GLAC SERVICE INSTRUCTION #1

**GREAT LAKES**  
AIRCRAFT COMPANY

GLAC SERVICE BULLETIN #4

DETAILS; MAIN LANDING GEAR AXLE (DRAWING NO. 2010.L)

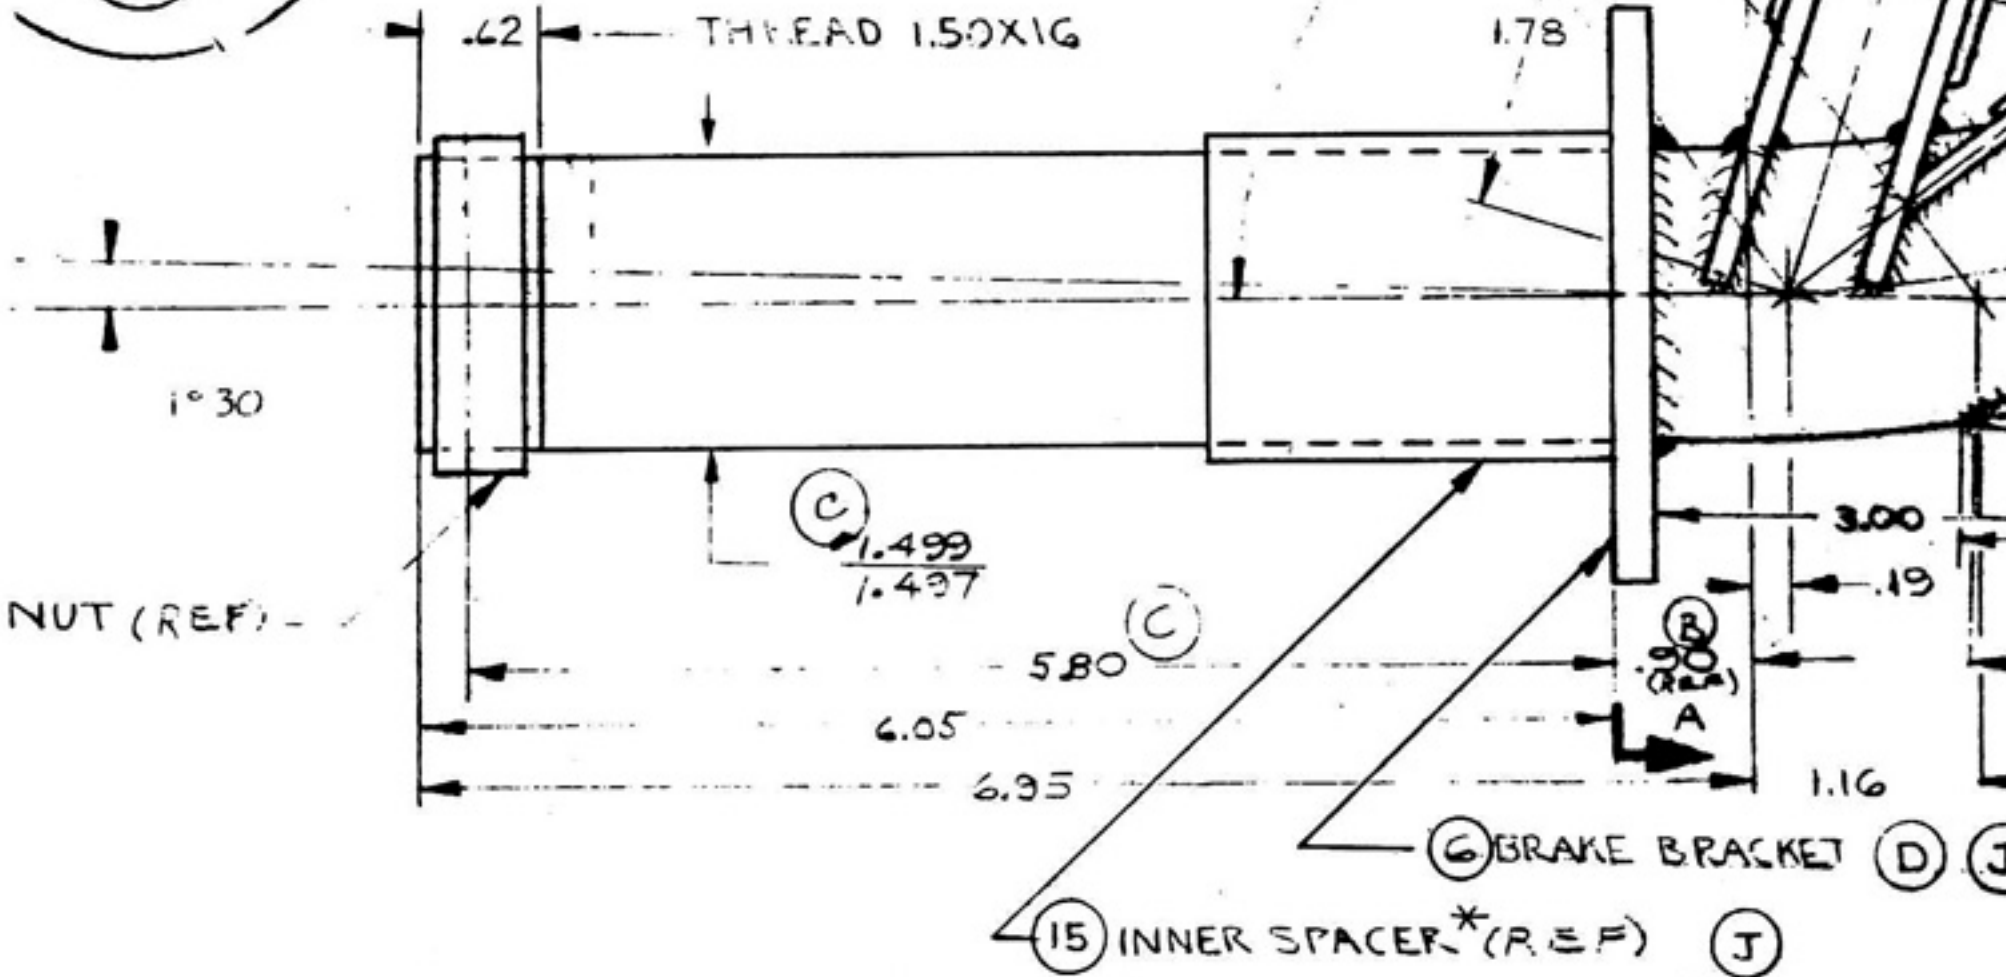
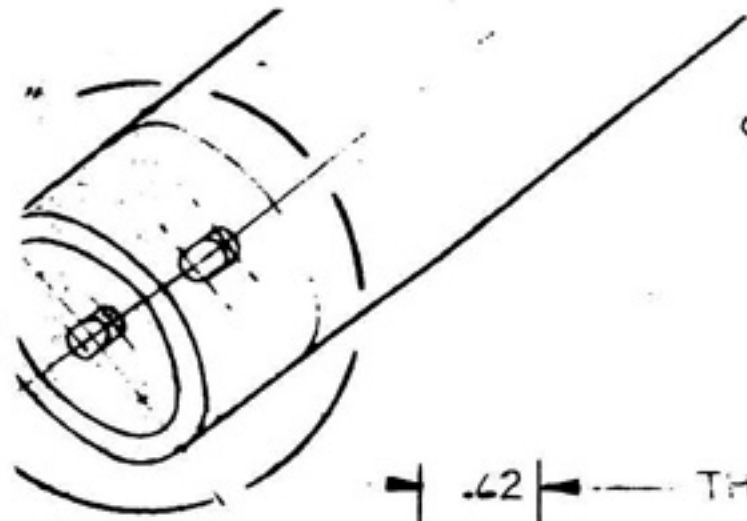
- 2.a. If a 20101-14 inner spacer is installed, it must be replaced with a -15. (A -14 has reduced diameters on both ends).
- b. If a 20101-13 is installed (identified by a reduced diameter on one end only) replace it with the reduced dia. on the INBOARD side.
3. Reassemble wheel & torque retaining nut to remove axial play. Ensure that the nut contacts the washer and clamps down on the bearing.

\* REPLACES -13 AND -14 SPACERS
